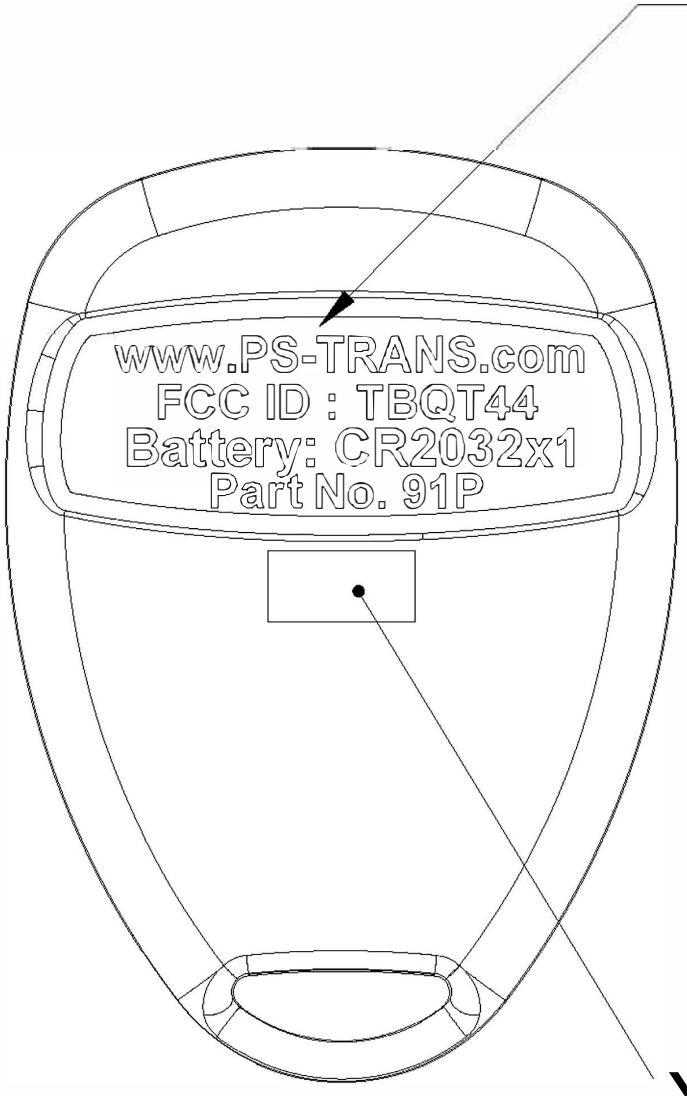
▲ New opening is made in the form of insert, insert surface is flat with the product surface, insert surface etch is consistent with the product surface, indented word, dented 0.15mm, literally polished.
